TENNESSEE VALLEY AUTHORITY

In the Matter of) Docket Nos. 50-327
Tennessee Valley Authority) 50-328

REVISED JUSTIFICATION FOR RELIEF REQUEST

Sequoyah Nuclear Plant units 1 and 2 feedwater system. Installation of 2-inch bypass lines around 16-inch feedwater check valves 3-508, 3-509, 3-510, and 3-511 (drawings attached) in accordance with TVA ECN L5024.

Sketch of Typical Value Arrangement For 1 Steam Generator Loop

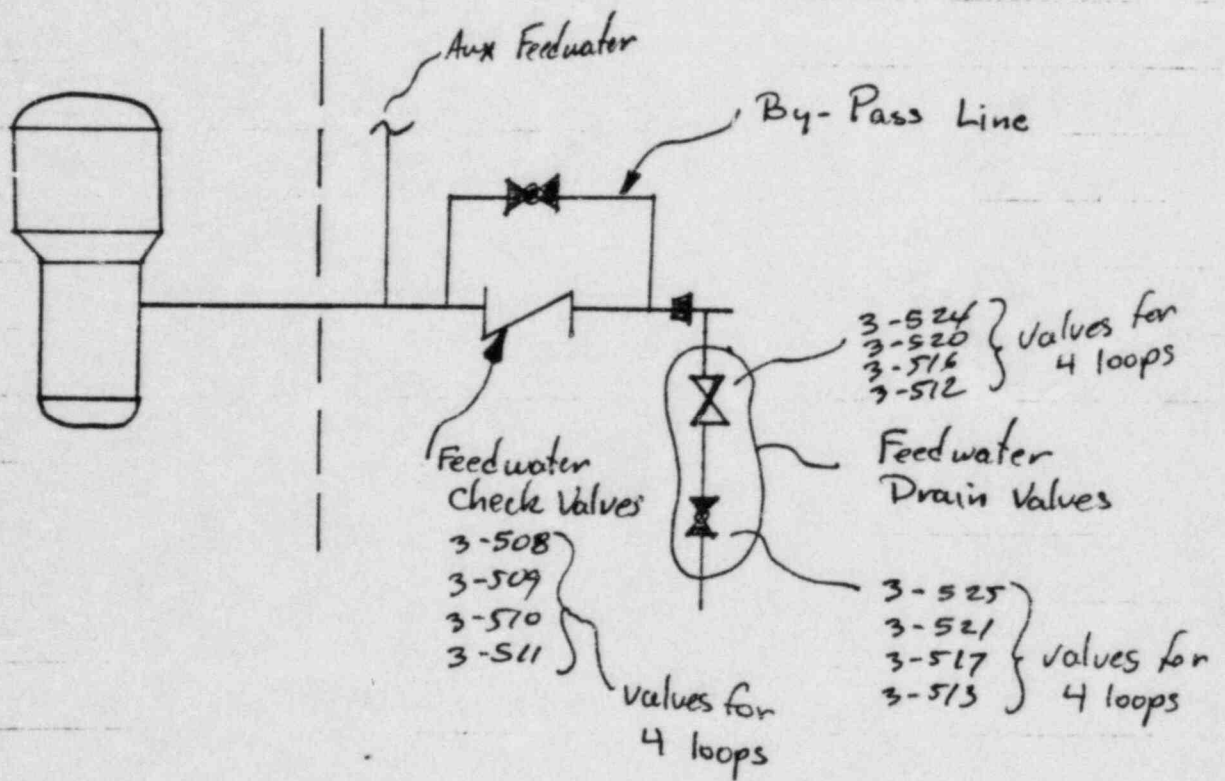
Deletion of 1-1/2-inch feedwater drain valves 3-512, 3-513, 3-516, 3-517, 3-520, 3-521, 3-524, and 3-525 (drawings attached). These valves are to be eliminated and the lines will be capped utilizing 1-1/2-inch socket welds.
